Exelon Generation®

RS-20-010

Braidwood Station, Units 1 and 2  
Renewed Facility Operating License Nos. NPF-72 and NPF-77  
NRC Docket Nos. 50-456 and 50-457

Subject: Application to Revise Technical Specifications 5.6.5, "Core Operating Limits Report (COLR)"

Figure B 3.2.1-1 (page 1 of 1)  
 $K(Z)$  - Normalized  $F_0(Z)$  as a function of Core Height

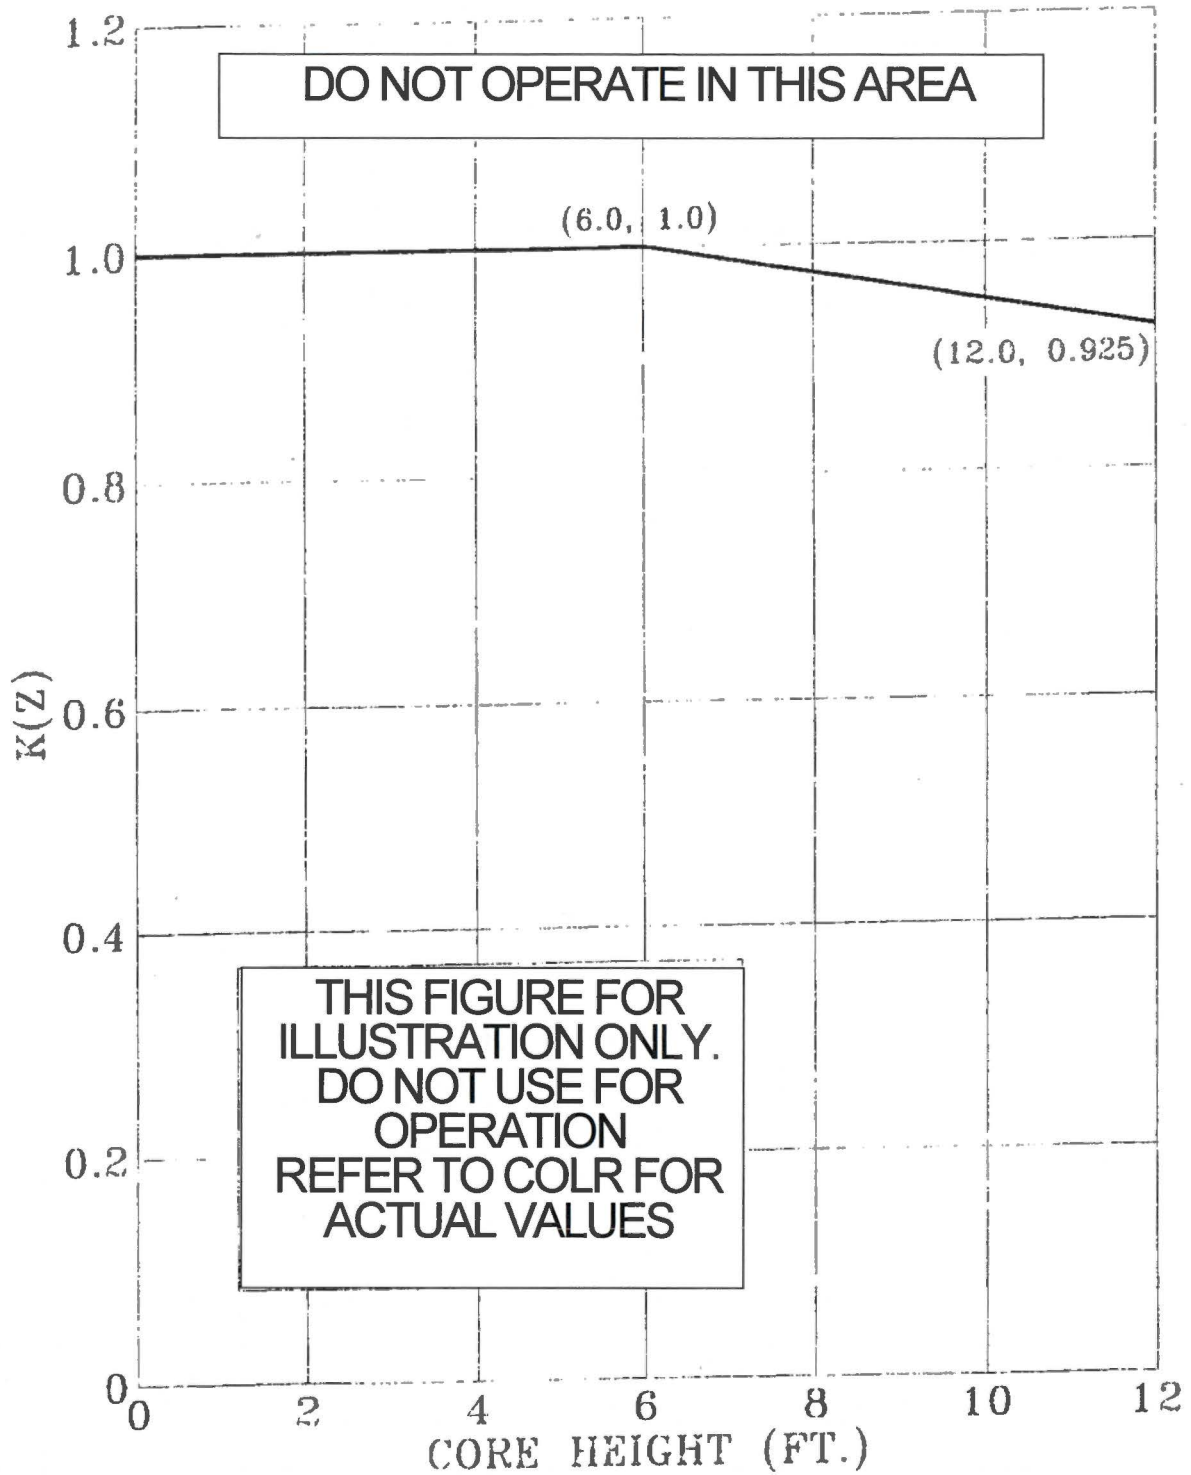
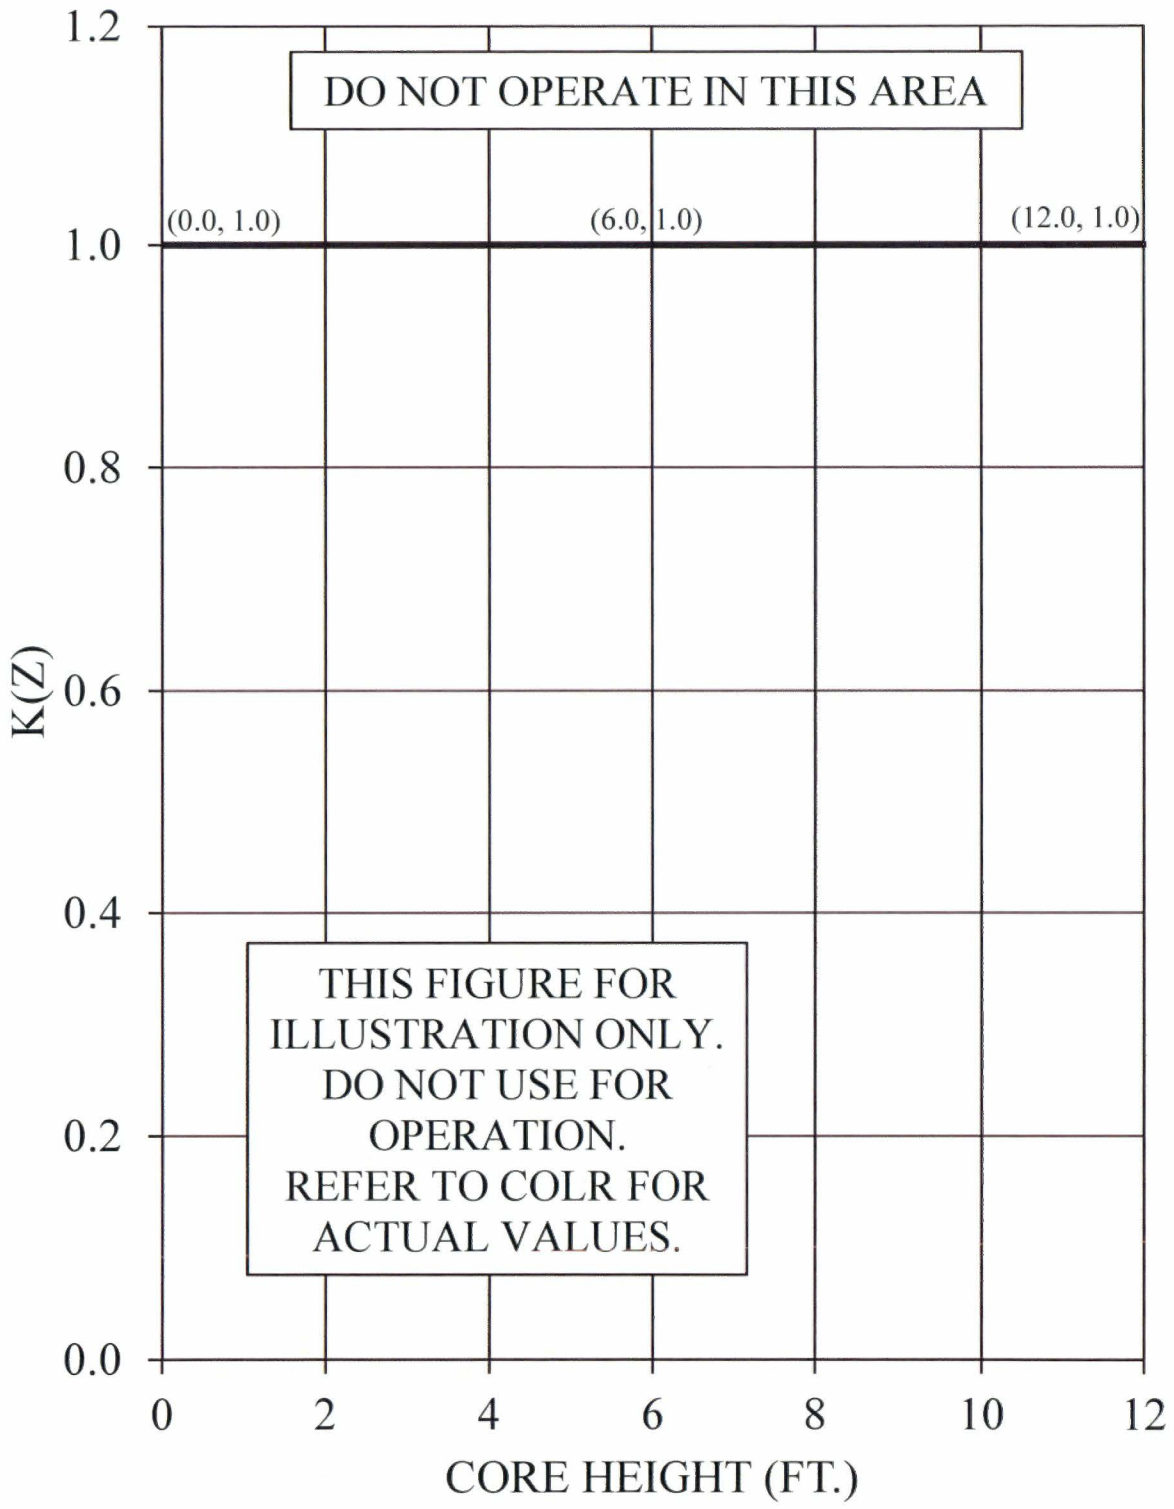
This figure is replaced with the figure on the next page.

Figure B 3.2.1-1 (page 1 of 1)  
 $K(Z)$  - Normalized  $F_0(Z)$  as a function of Core Height

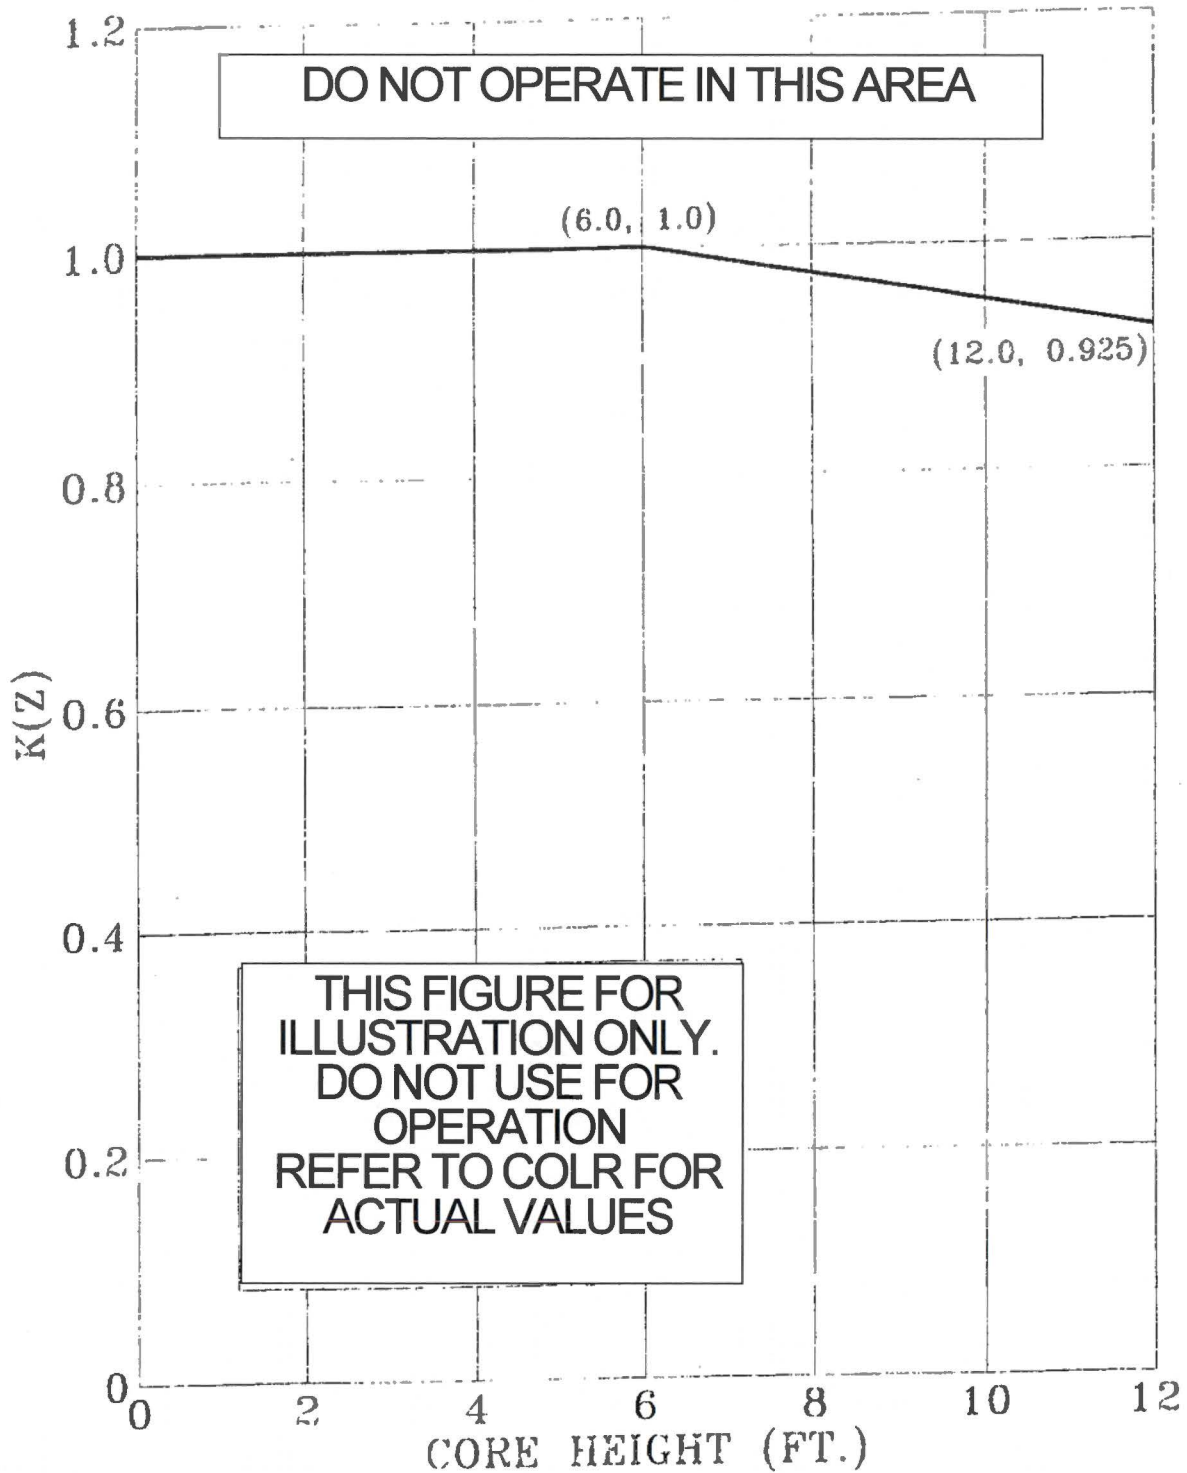
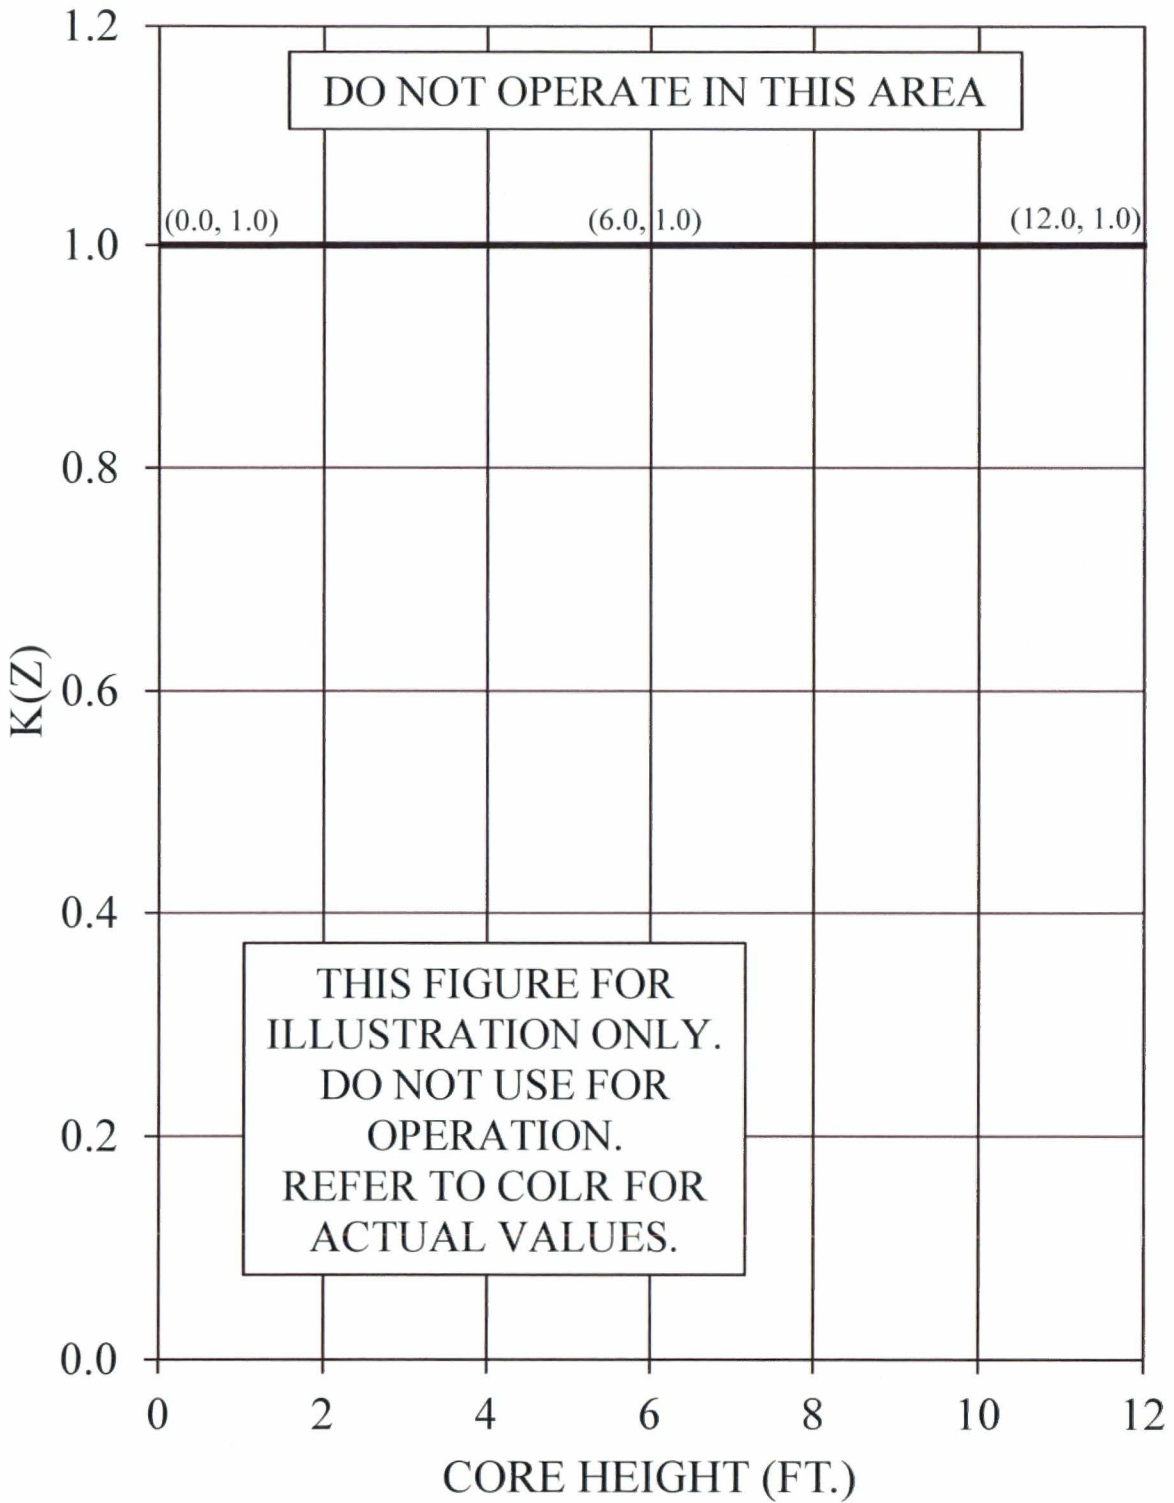
This figure is replaced with the figure on the next page.
